## MEMORANDUM

**Subject:** Second Series of Meetings: Stakeholder/Technical Advisory Group/Far North Bicentennial Park User Group Meeting Notes

INITIAL TRAIL CROSSING CONCEPTS FROM OCTOBER 16,17 MEETINGS  
**EARTHEN OVERPASS CONCEPT**

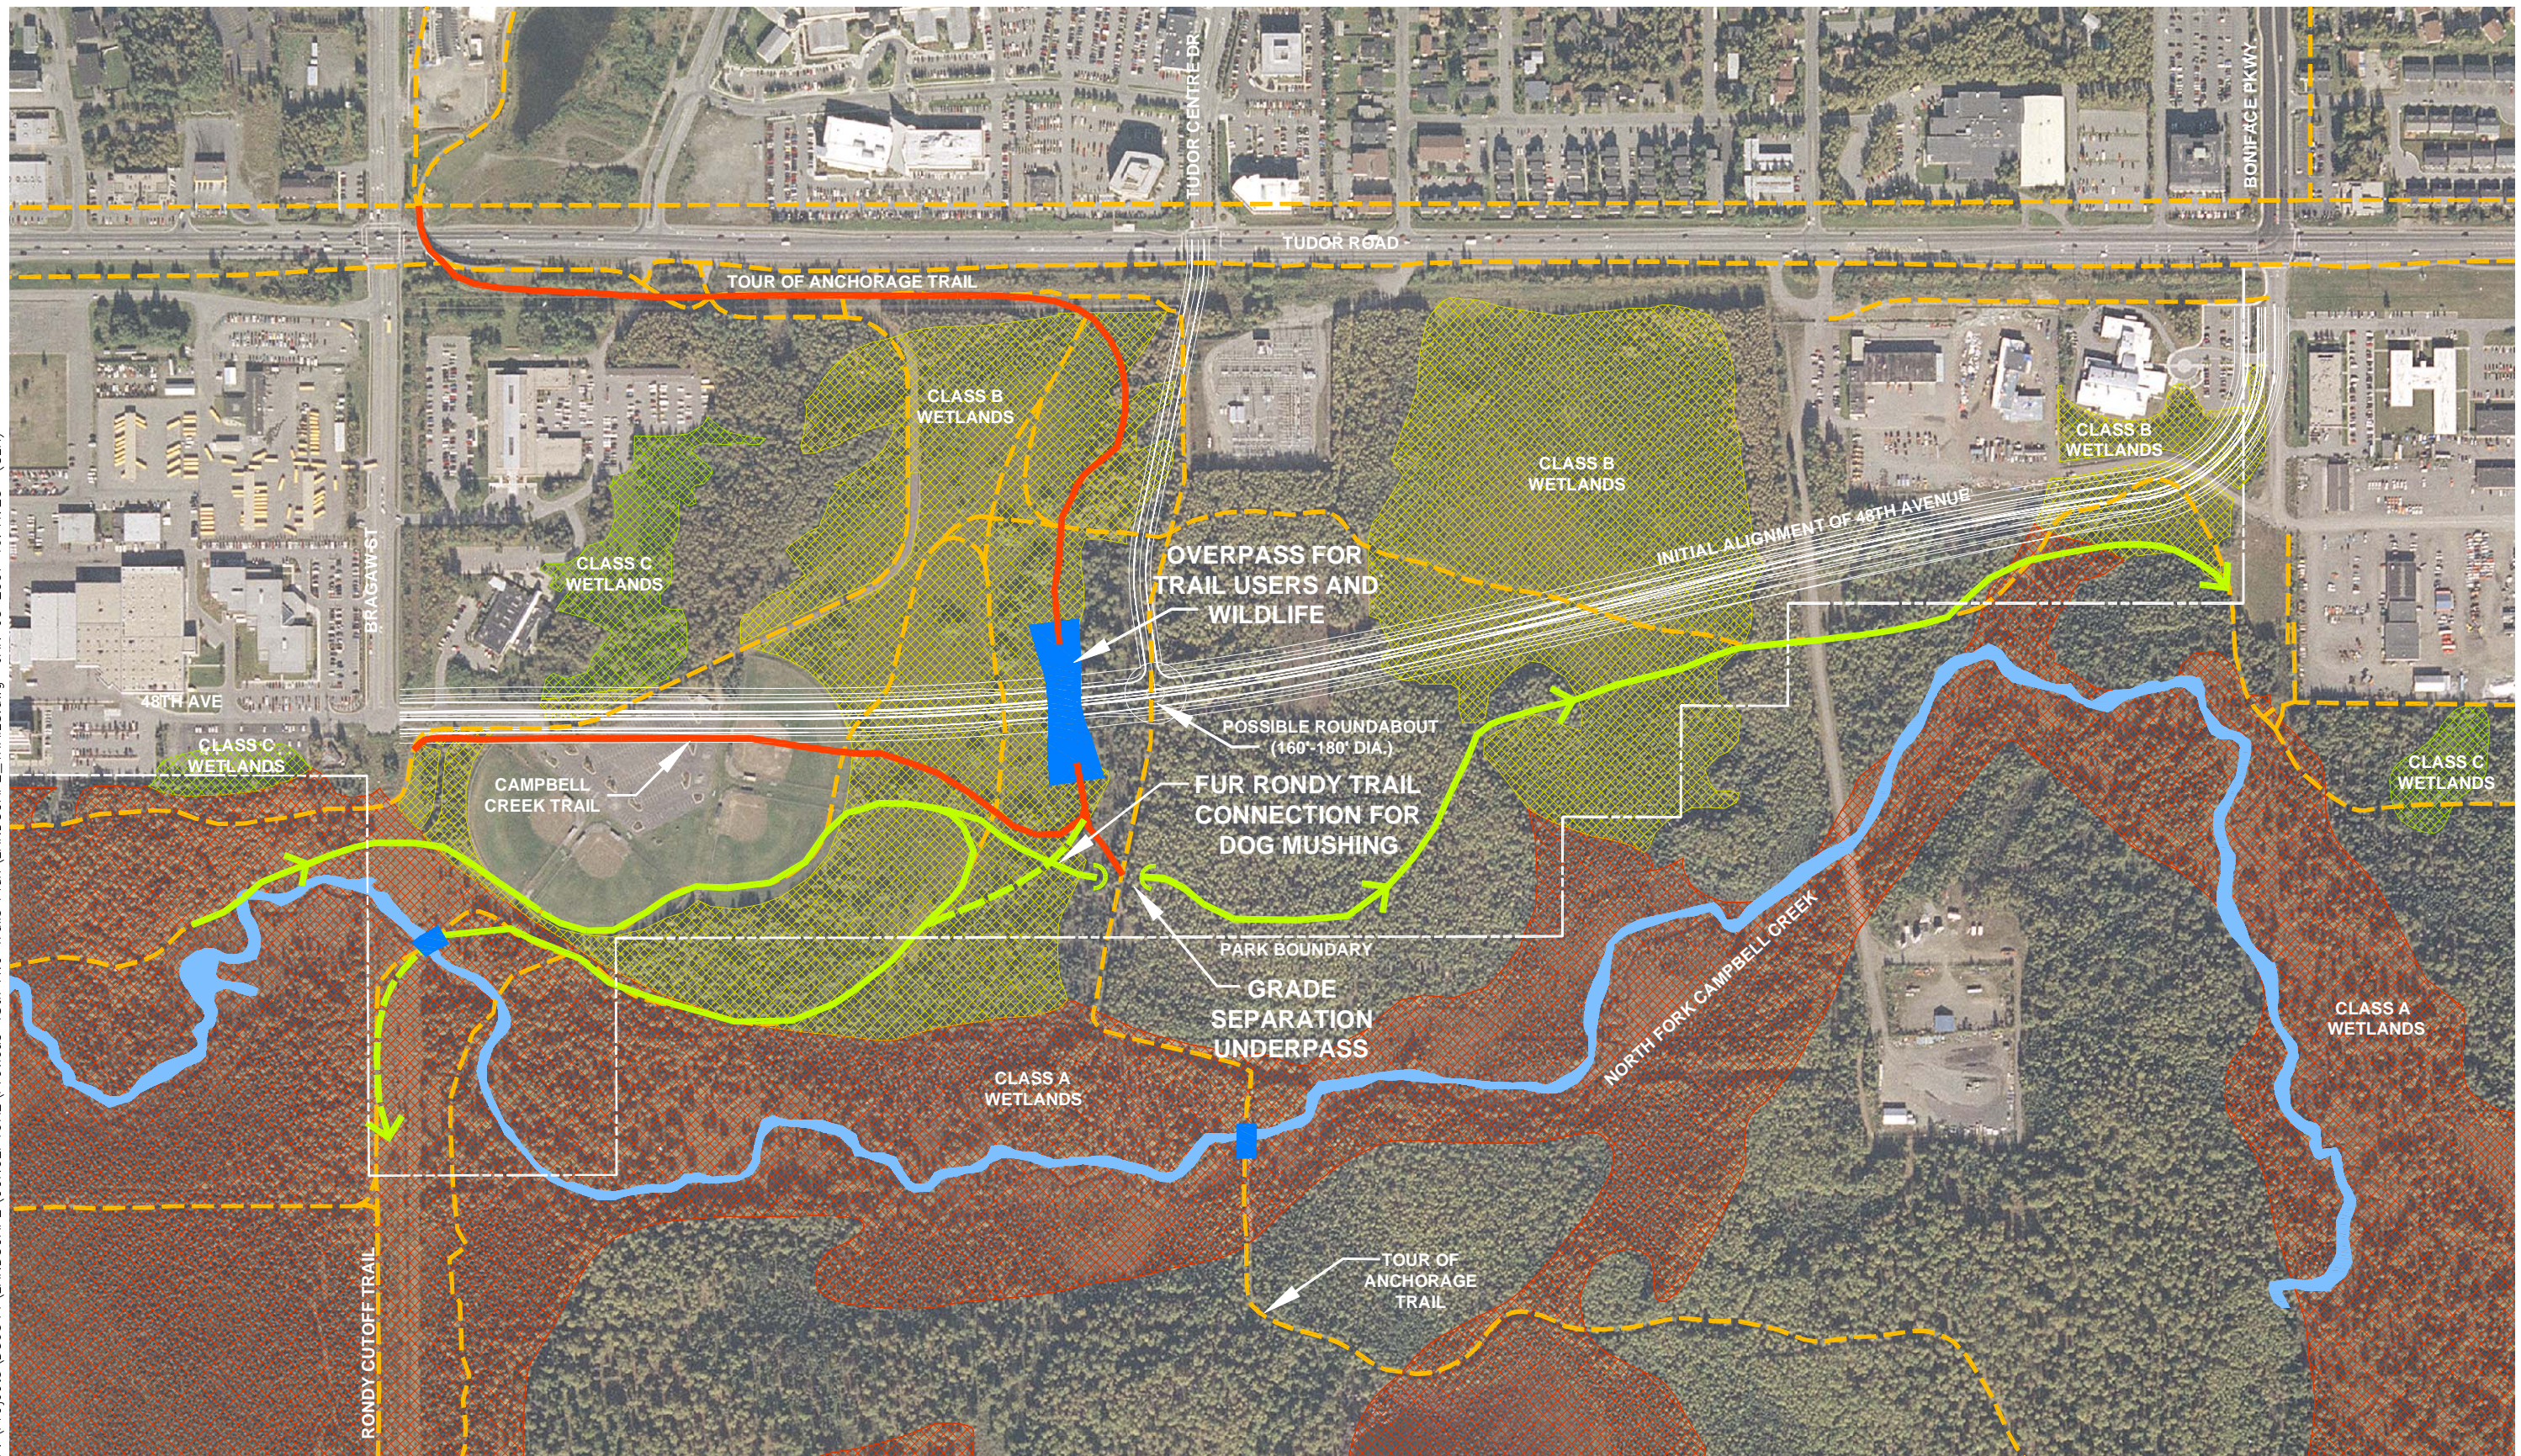
#### **Concept 1: Earthen Overpass**

- If you can make this work, it's great.
- Great concept! There are multiple trail users including wildlife.
- Pedestrian, biking, skiing users generally prefer overhead crossings rather than tunnels or under bridges.

- Separated trail on south side and buffer away from road so that snowplows don't pile snow on top.
- We need a park entrance/gateway for people to access FNBP from the north.
- Can we share parking at the ball fields? Can we park in lots used by new city buildings?
- If you're looking for a trailhead with parking in any alternative, use Chuck Albrecht fields existing parking or try to share with municipality buildings on the north side.
- A problem of this alternative is that when the budget people look at it, the overpass could be trimmed to 12 feet to match the bridge over Tudor and the split grade for the dog trail can be deleted.
- Best option of the three. Work to make the overpass as wide as possible.
- Best option for Tour of Anchorage (TOA) 75 feet to 100 feet would be wonderful.
- In all alternatives send the road around the north of the ball fields.

INITIAL TRAIL CROSSING CONCEPTS FROM OCTOBER 16,17 MEETINGS  
**OVERPASS / UNDERPASS CONCEPT**

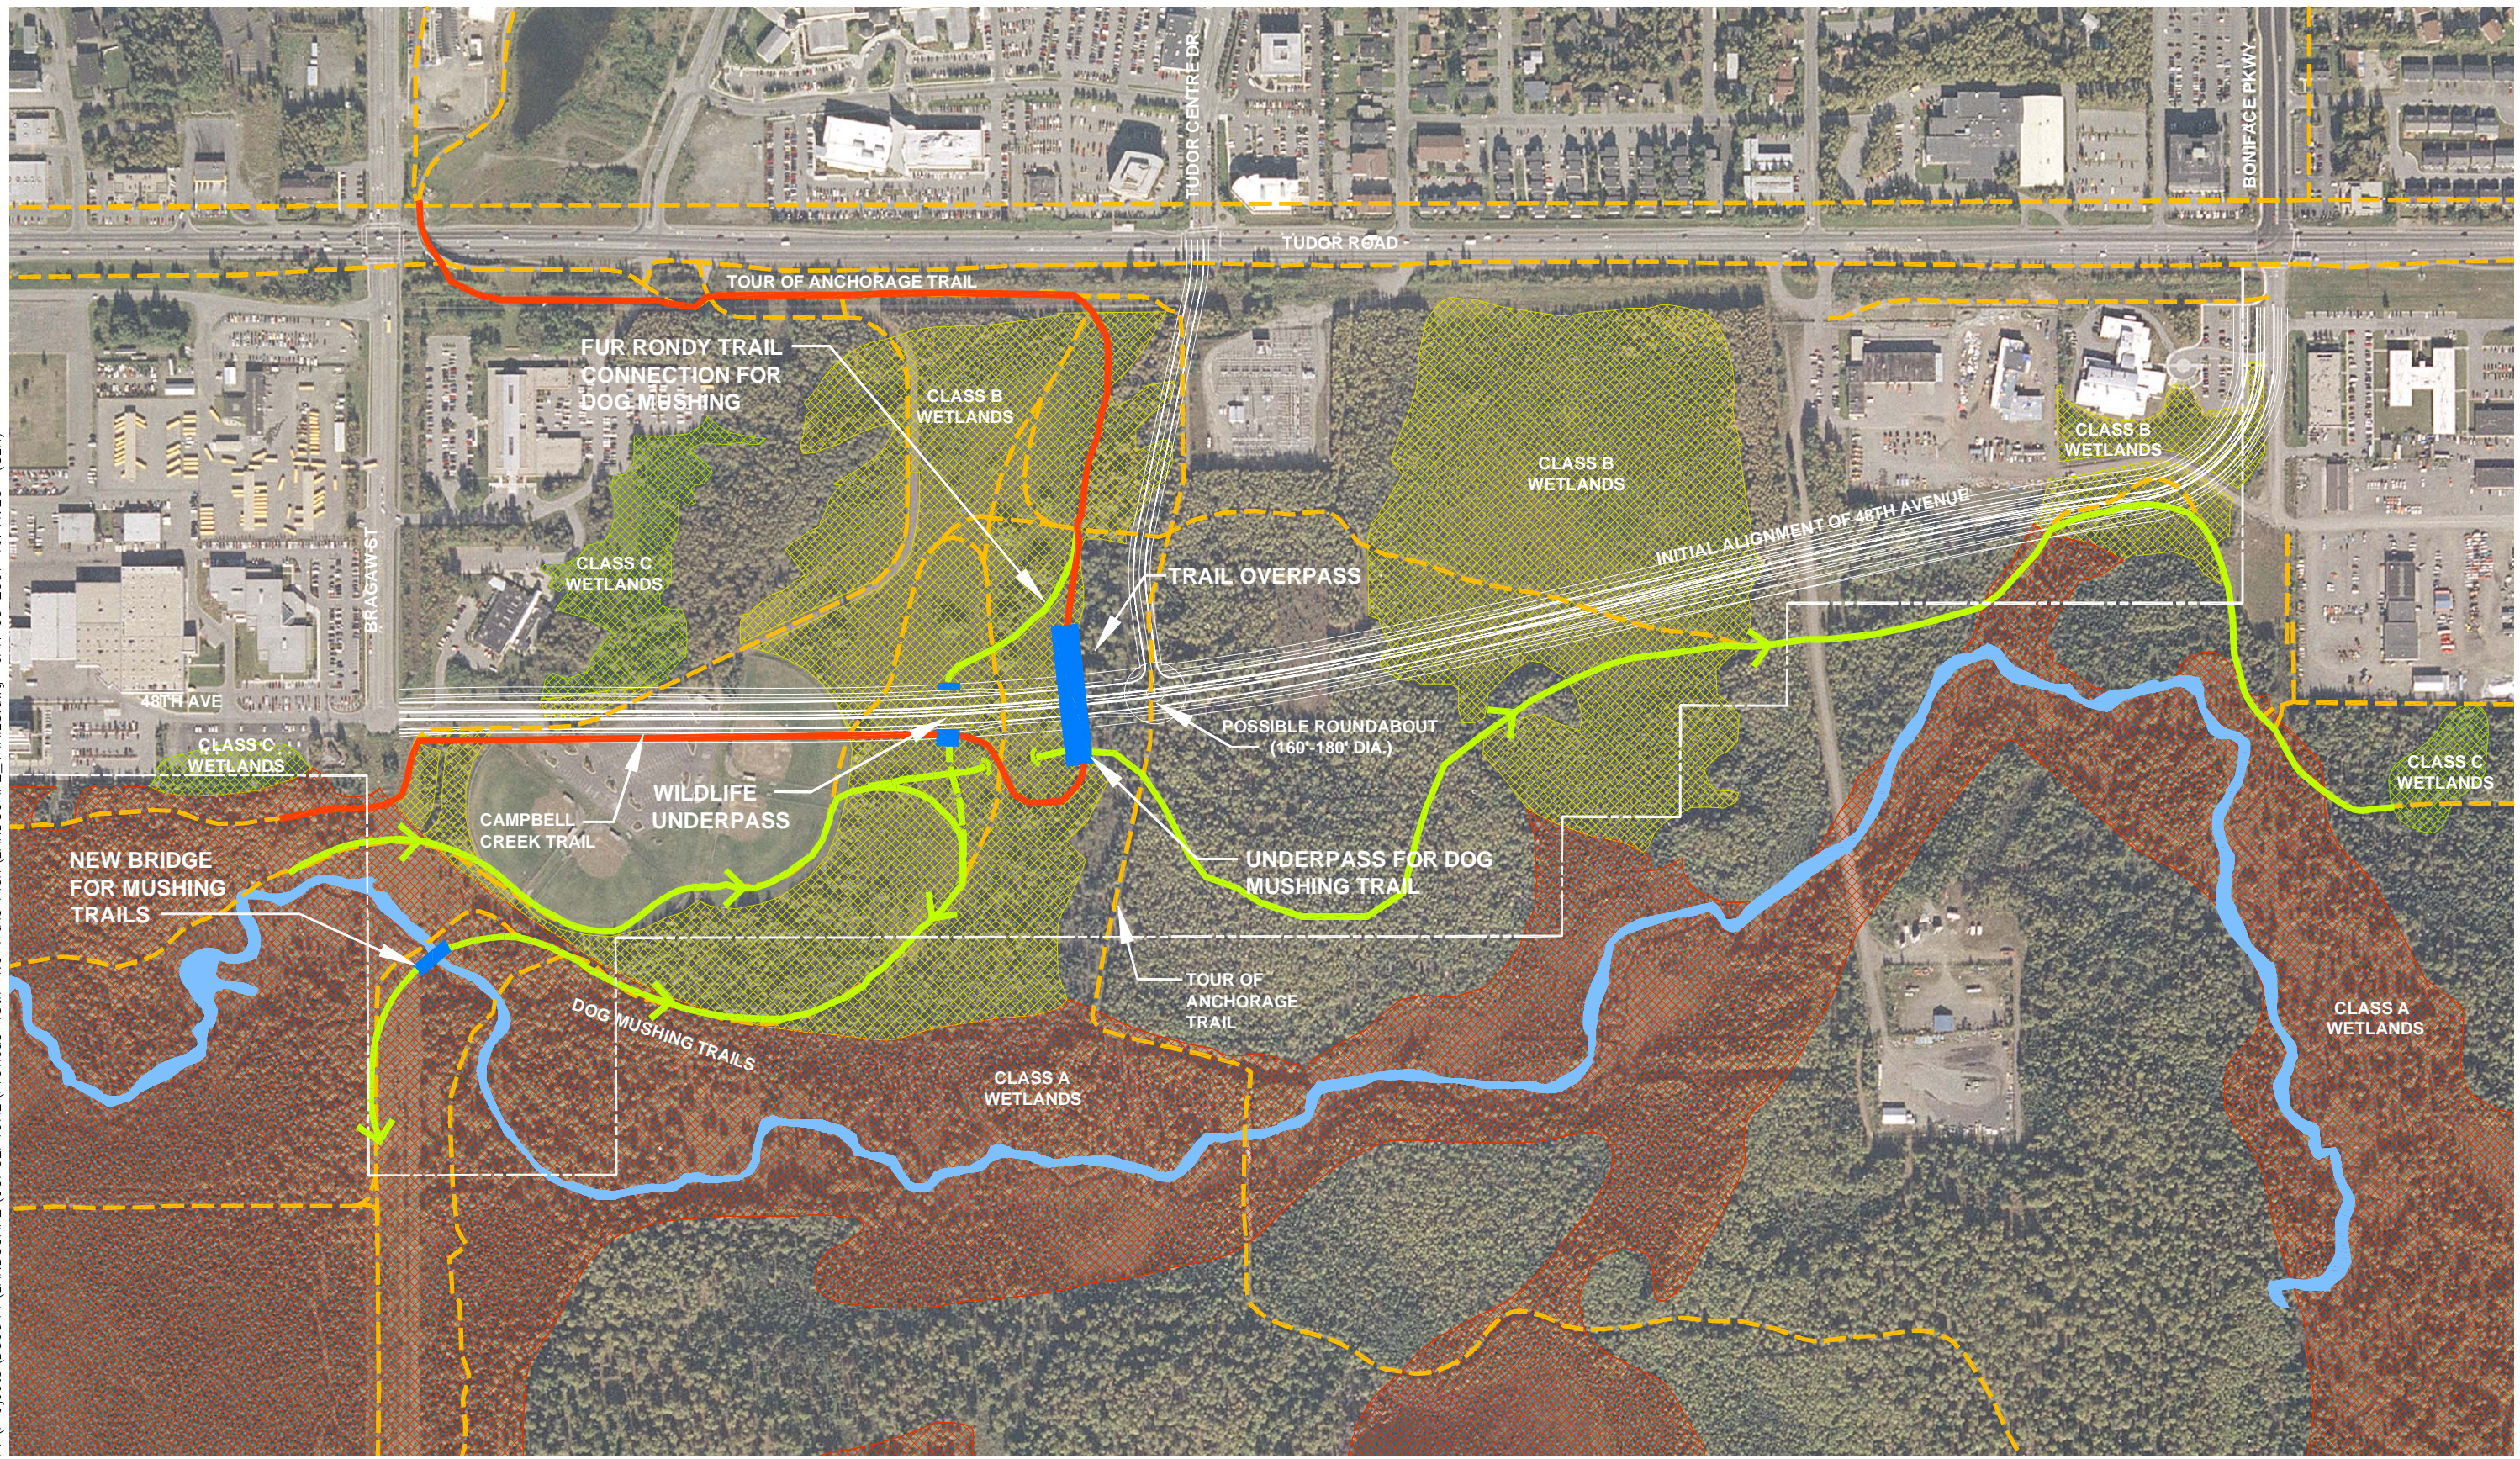
- Campbell Creek trail is very popular in winter and summer. It should be separated from 48th Avenue as much as possible for aesthetics and for snow grooming in winter. Trail separation is far more valuable than a median strip.

- Campbell Creek Trail junction with tour junction should provide for smooth flow to north or south.
- Overpass should curve out over low wetlands to allow road to pass beneath with minimal earth movement. Curved bridge clears potential roundabout.

- Separate wildlife underpass far enough from trail overpass so road can be elevated above wetland yet be able to dive beneath trail overpass (section sketch of wildlife overpass with curved trail bridge across proposed 48th Avenue that reflects curve of roundabout).

- I don't like sharing overpass with big wildlife like bears and moose, and they don't like to share trails with humans.
- Mushing trail is too close to 48th Avenue.

- Move underpass for mushing trail to south of overpass and avoid going under Tour Trail overpass altogether.
- Get rid of underpass under bike path Tour Trail overpass. Mushing trail crosses ski trail in one place and does not cross Campbell Creek Trail.

- Put road around Albrecht ball fields to save ball fields and put paved bike trail around too. This could slow traffic to maintain 35 miles per hour speed.

- Define trail corridor and legally protect it.
